Project Location:	0 Mandela Parkway. The vacant parcel is located across from the neighboring property at 3650 Mandela Parkway and next to Beach Street and Target store.
Assessor's Parcel No:	007 061701405
Development Proposal:	To construct a six-story building "Mandela Hotel" consisting of 220 rooms measuring approximately 142,813 square feet of floor area with two-levels of underground parking garage and a small open parking area totaling 166 parking spaces.
Project Applicant / Phone Number:	Joanne Park, lead architect for Architectural Dimensions / (510) 463-8300
Hotel Operators:	Tulsee Nathu & Payal Nathu
Property Owner:	State of California
Case File Number:	PLN16394
Planning Permits Required:	<ol style="list-style-type: none"> 1) Major Conditional Use Permit for non-residential projects with more than 25,000 square feet of floor area; 2) Minor Conditional Use Permits for transient habitation (Hotels) and non-residential tandem parking; 3) Regular Design Review for new building construction; and 4) Minor Variance for front yard setback reduction.

CITY OF OAKLAND PLANNING COMMISSION

Case File: PLN16394

Date: March 20, 2018
To: Mike Rivera, Project Case Planner
From: Sharon Wr

Google Street View – 8/2017 view southwest of frontage

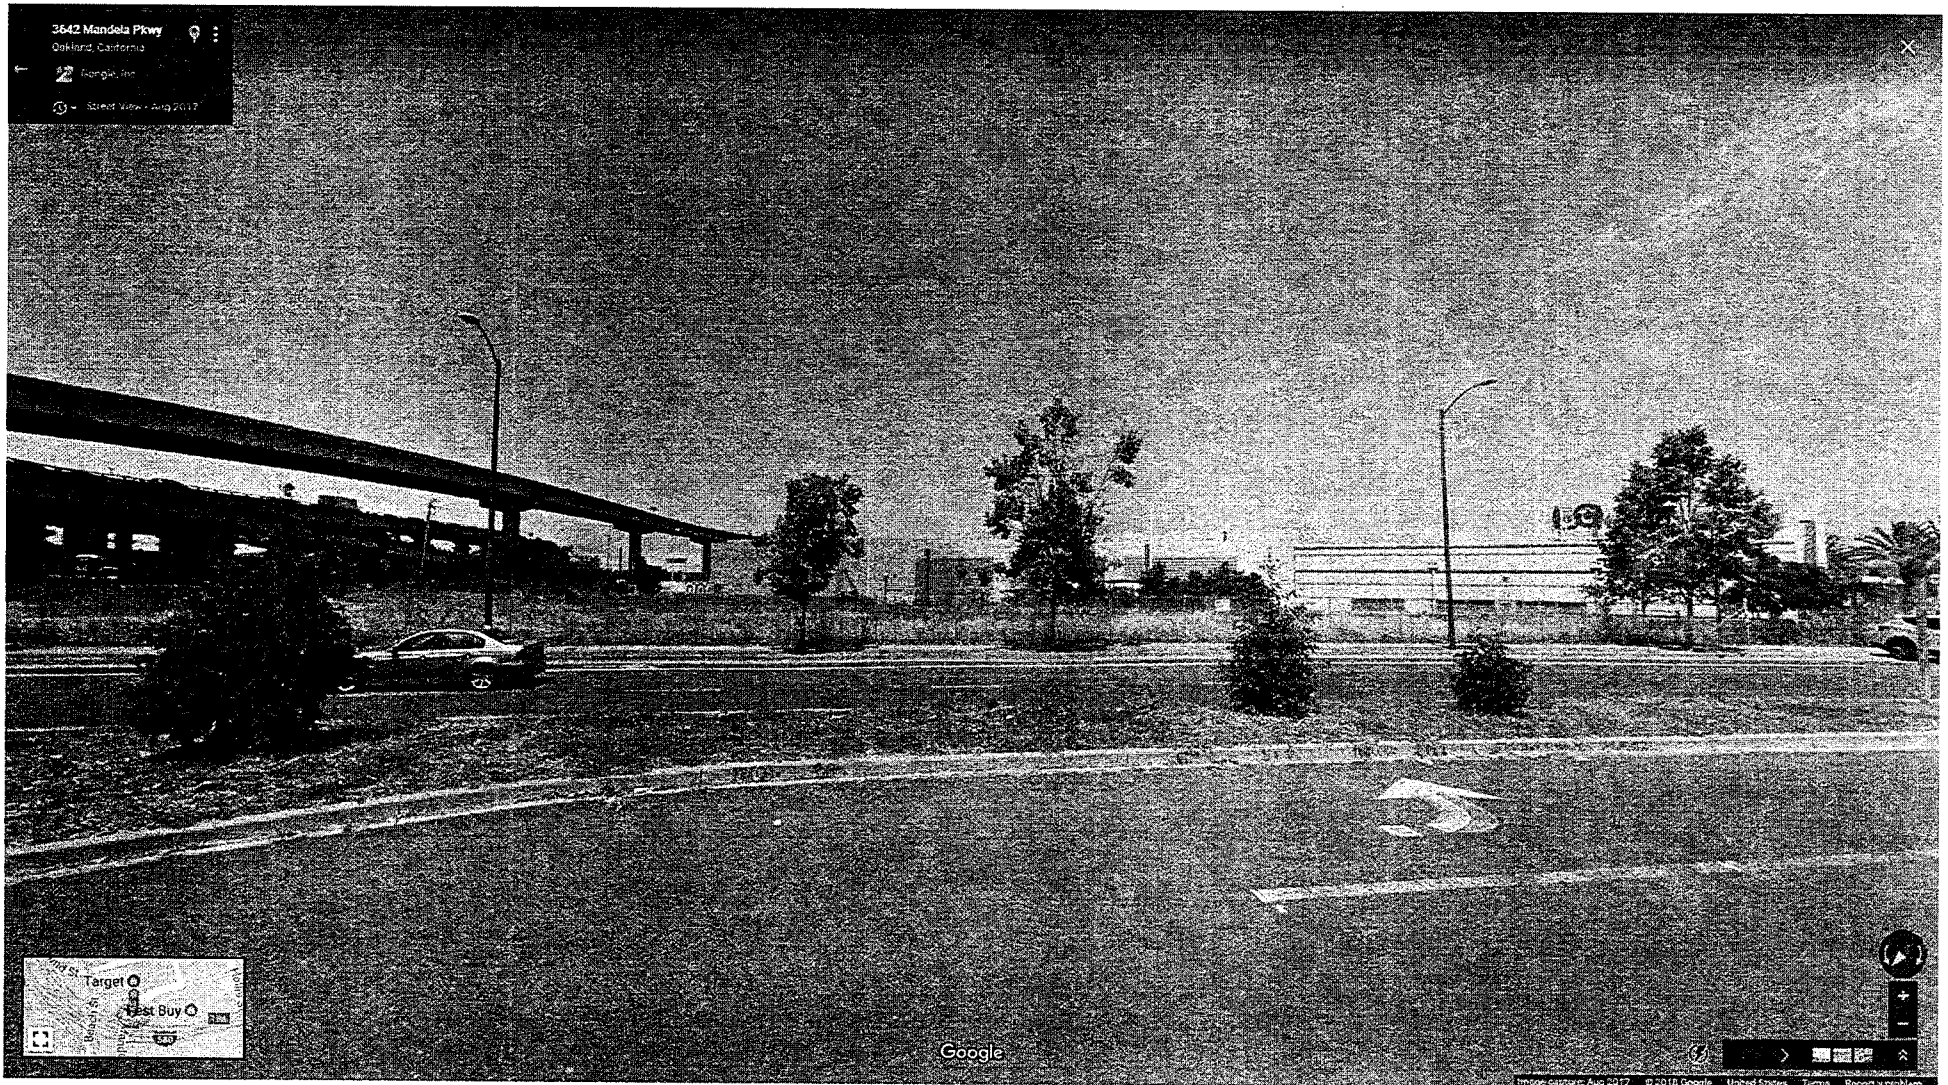
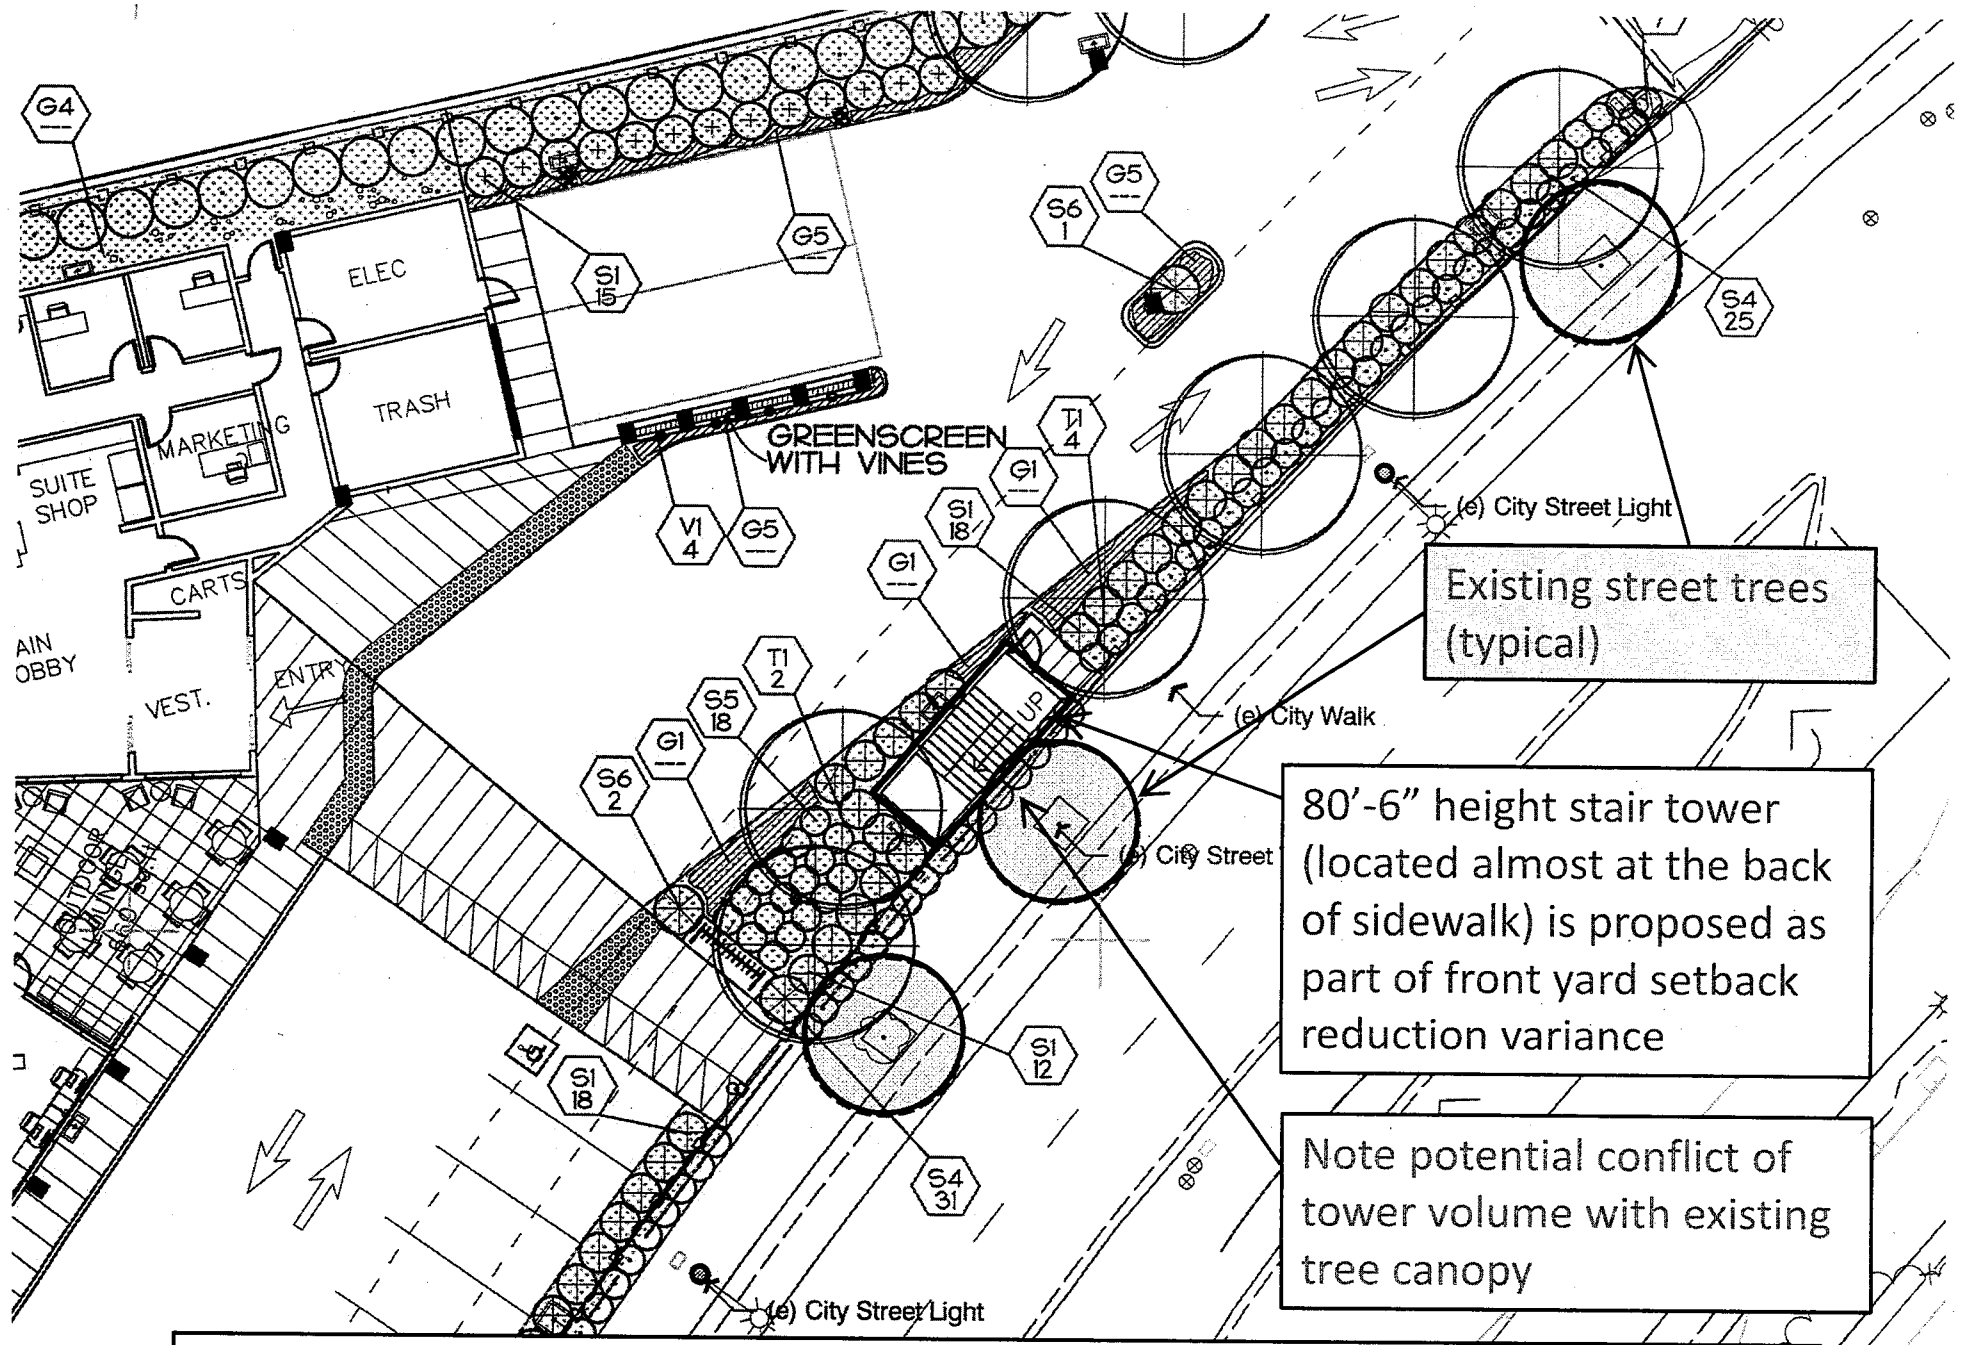
- These suggestions are made not to burden the developer; they are to ensure that the project's design take into account the real conditions of the public realm along the boulevard (e.g. problematic tendencies of dumping, vandalism, graffiti, etc., as well as scarce City resources for right-of-way landscape maintenance) and to ensure that it realizes benefits for both the community and for itself, as a welcome new neighbor, an important set of "eyes on the street" and in the neighborhood, a provider of jobs, a hospitable setting for pedestrians and users along Mandela Parkway, and a catalyst for investment and care along the corridor.

Note the existing sparse and stunted street tree canopy & landscape along the site's Mandela Parkway sidewalk and along the center median (outlined in red)

Note the existing sparse and stunted street tree canopy & landscape along the site's Mandela Parkway sidewalk and along the center median. Pedestrian buffering from cars/trucks is ineffectual. 5

Note the existing sparse and stunted street tree canopy & landscape along the site's Mandela Parkway sidewalk and along the center median. Pedestrian buffering from cars/trucks is ineffectual. 6

Note the existing sparse and stunted street tree canopy & landscape along the site's Mandela Parkway sidewalk and along the center median. Pedestrian buffering from cars/trucks is ineffectual. 7

Note the existing sparse and stunted street tree canopy & landscape along the site's Mandela Parkway sidewalk and along the center median. Pedestrian buffering from cars/trucks is ineffectual. 8

Enlarged Mandela Parkway frontage rendering from Sheet DR-10

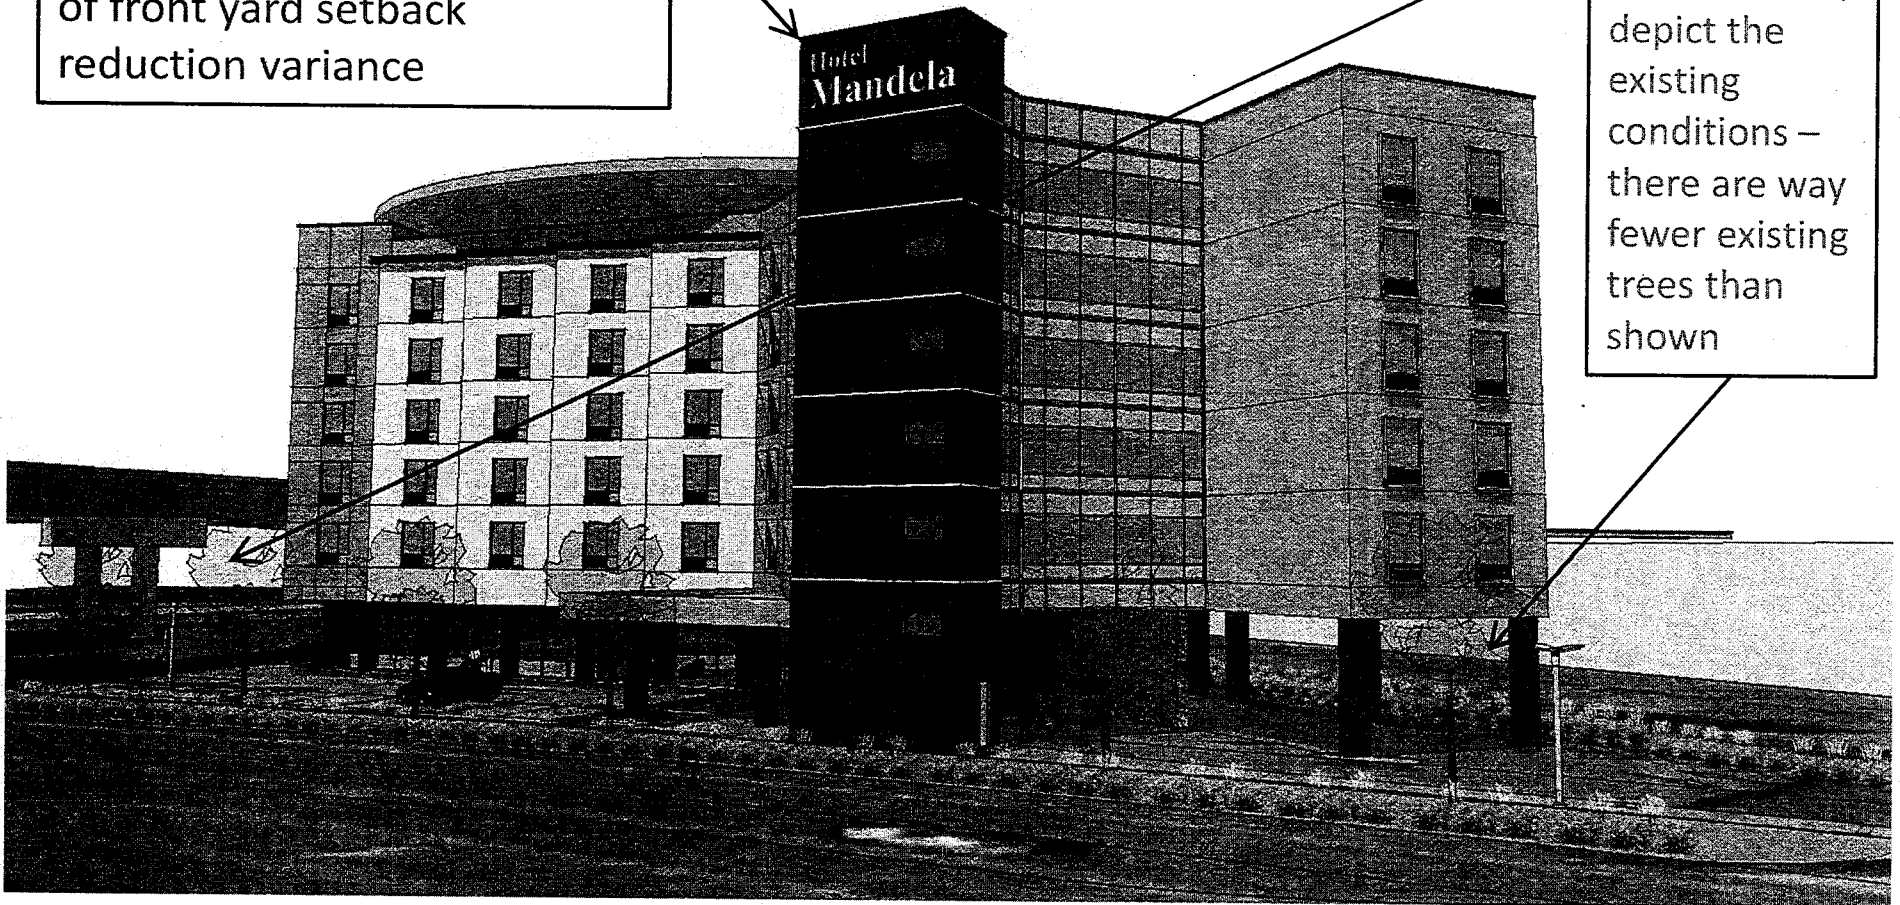
80'-6" height stair tower (located almost at the back of sidewalk) is proposed as part of front yard setback reduction variance

Material Finishes/Color Palette from Sheet DR-11

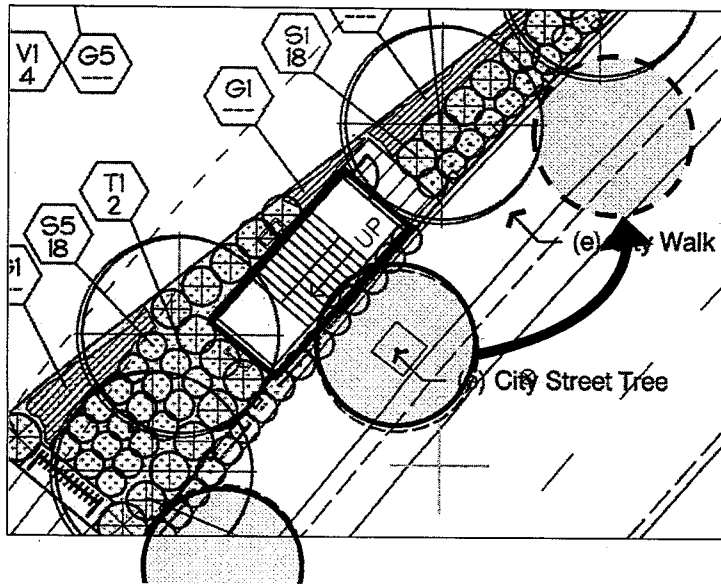
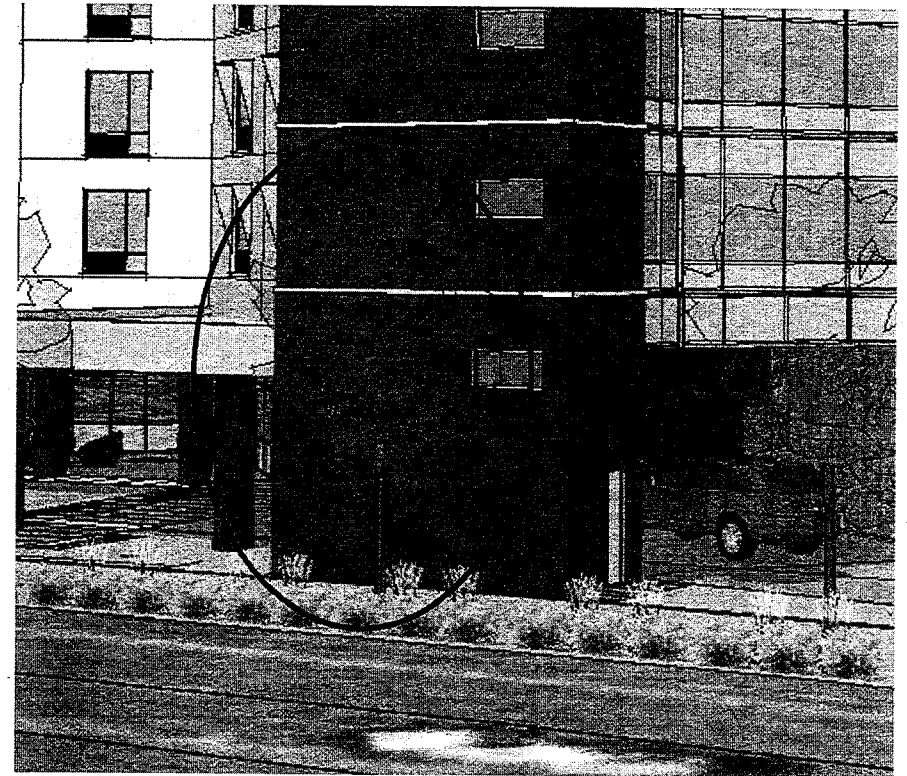
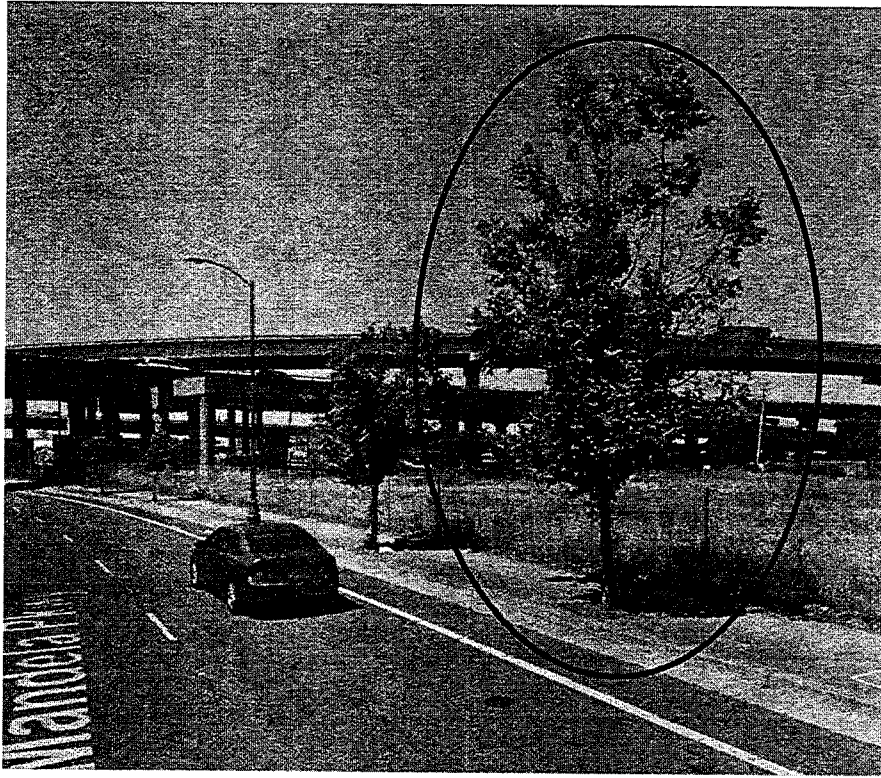
Proposed Tower cladding to be dark bronze Metal Wall Panel (Alucobond or equivalent)

- Existing London Plane tree is not in great shape. Probably won't do well & look good in front of tower with tight fit (branches will need to be cut anyway).
- Suggest removal and planting of a new London Plane tree about 30 feet further northeast along sidewalk.
- Suggest tower (behind fence or not) to be clad with graffiti- & vandal-resistant finish (ceramic tile?) to 16 ft height and building-mounted luminaires light the sidewalk for safety (like at 2855 Mandela Pkwy). Decorative mosaic? Public art opportunity?
